Ducted Systems Technical Services Service Letter

Letter: **YS-005-2019**

Subject: **Direct Spark Ignition (DSI) Control – Indoor Blower Motor Operation**

Product: PCG6, PHG6 - **2 stage** gas model LX series residential package units

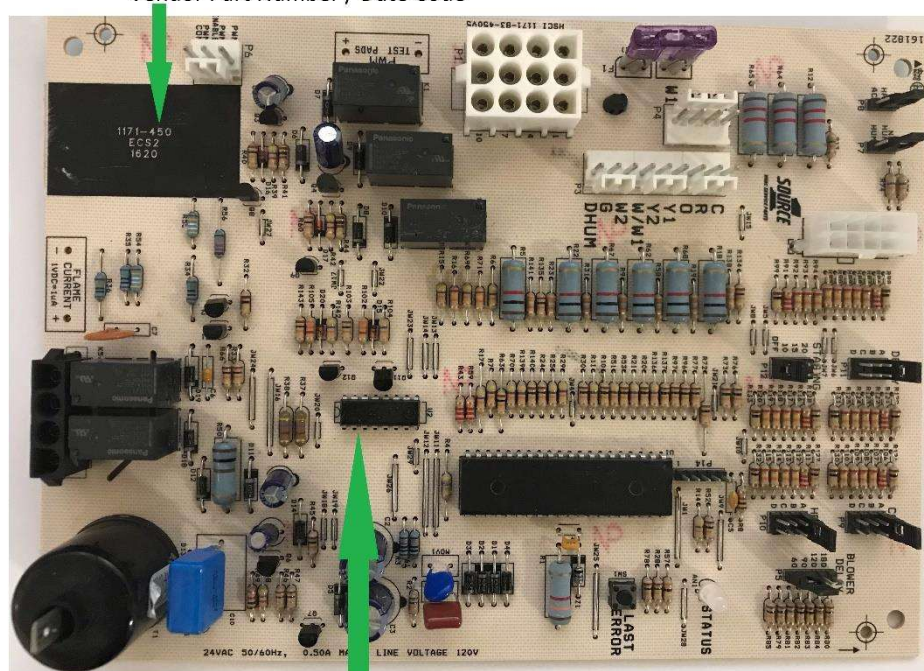
We have received a few complaints of erratic indoor blower motor operation on recently installed multi-stage PCG6 model package units. During HIGH heat (W2) operation, the PWM signal sent from the DSI control board to the blower motor can fluctuate causing the indoor blower motor to ramp up and down.

It was discovered that the DSI control board vendor used an alternate PWM micro-processor component supplier without our testing or approval. The original control design used a component manufactured by STMicroelectronics. If the control board contains the alternate PWM micro-processor, erratic indoor blower motor operation **may** occur during HIGH heat (W2) operation. Suspect control boards were manufactured between December 2017 and March 2019. Controls within this date range may contain either PWM micro-processor. Due to this fact, a DSI control manufactured within the date codes listed above does **not** mean it is defective. The component manufacturer is marked on the face of the PWM micro-processor. PWM micro-processors manufactured by STMicroelectronics have “ST.” printed on the face of the component and should function as designed. The marking is so small however, a magnifying lens is required to read it.

Date Code WEEK / YEAR

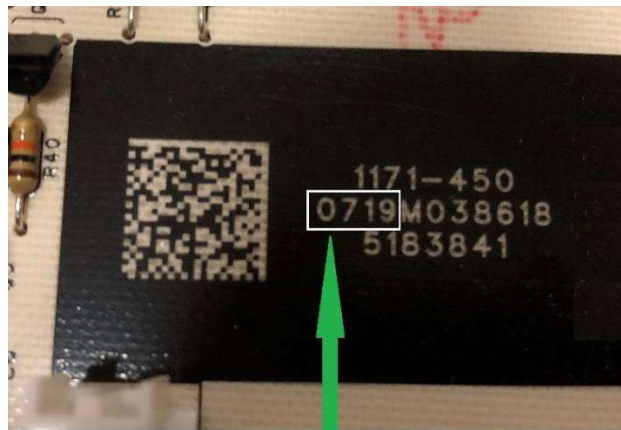
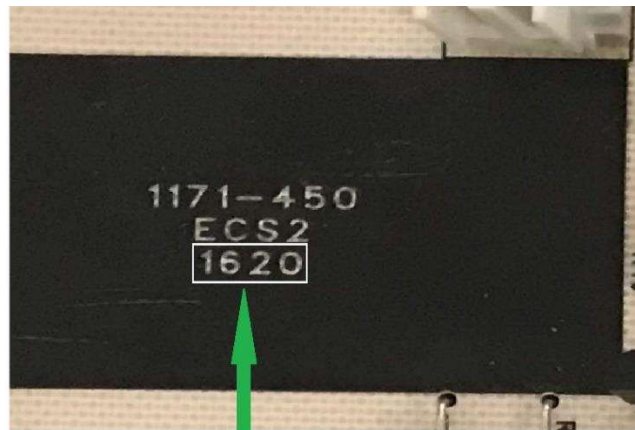
DSI Control boards have been manufactured at two different facilities. Depending on which facility the board was manufactured at, the date code nomenclature is different. Below is an image of both versions of date code nomenclature.

Suspect DSI control board date codes will read 4817 through 1019 or 1748 through 1910 depending on date code nomenclature.

On 03/05/19 all suspect model numbers in our distribution center were placed on quality hold for inspection. All suspect control boards in our factory inventory were returned to the control board vendor. All Source One inventory has been inspected and approved as correct. For equipment repair, order control board only using part number **S1-03103514000**. If your spare parts inventory has any S1-33103514000 control board kits in stock, they should be inspected using the same date code process shown above. If you find a suspect control board kit, contact S1 for a replacement. S1 kits shipped AFTER 03/26/19 are confirmed to be good.
